Issue 1

Our proposed route options: an overview

Figure 7. Option 12

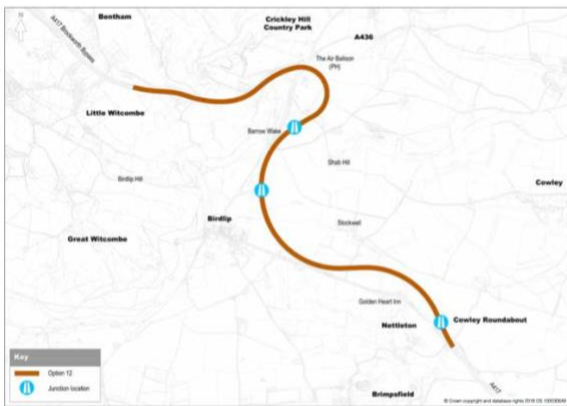
The question remains as to why the two designs that went to consultation had very different junction designs, with Option 12 having three junctions, whilst Option 30 only one¹. It can be clearly seen from the scheme proposals presented for consultation², that Option 12 had additional junctions that were considered not necessary for Option 30. This was meant to be explained by the traffic expert during ISH2 Agenda Item 8, but it was not.

Question: Put simply, can the ExA be appraised **again** as to why Option 12 had a junction at Cowley Roundabout in the design put forward for consultation, whilst it was assessed that Option 30 did not require it. The Applicant's response to the previous question has not provided a credible response. The ExA must now

Highways in their summary of Oral Submissions at Issue Specific Hearing 2 (ISH2)³ stated that *Junction layouts differed between the two schemes for engineering reasons related to level differences and geology.*

Figure 8. Option 30

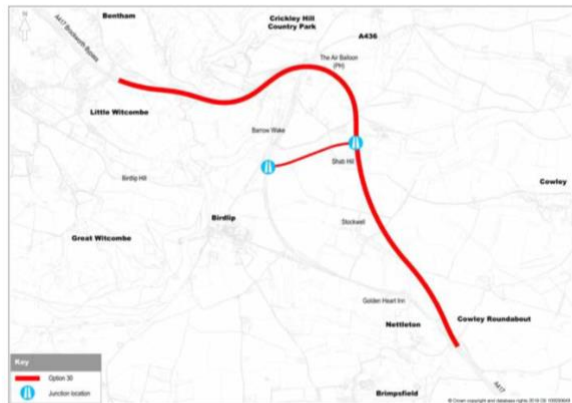
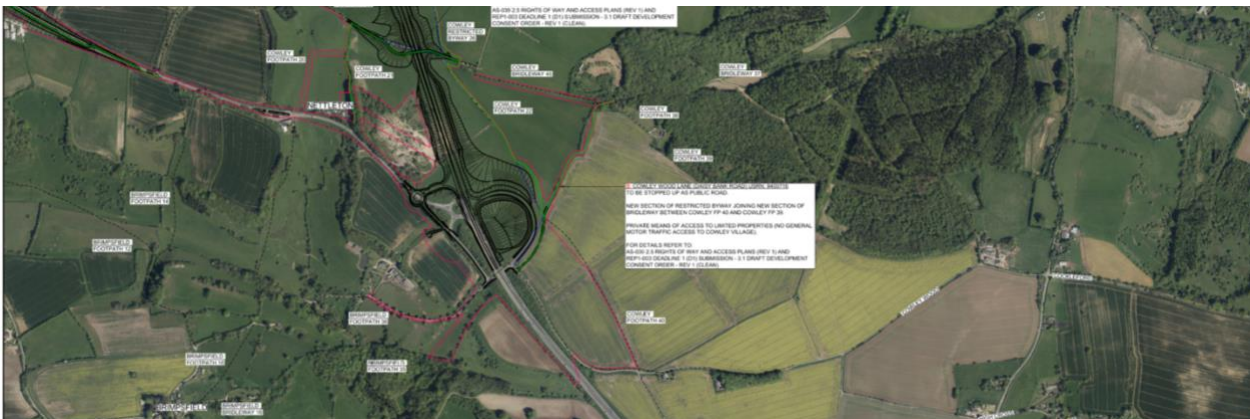
Image taken from A417 Consultation Brochure, showing the 2 route options that were presented at the time of the Public Consultation in 2018. Clearly there is no junction at the Cowley Roundabout for Option 30, and Highways state that this is *for engineering reasons related to level differences and geology.*

I think it is clear from the above that *level differences and geology* were not reasons for omitting a junction at the Cowley Roundabout at the time of Consultation, as the current Option 30 has a junction in the same location as that for Option 12.
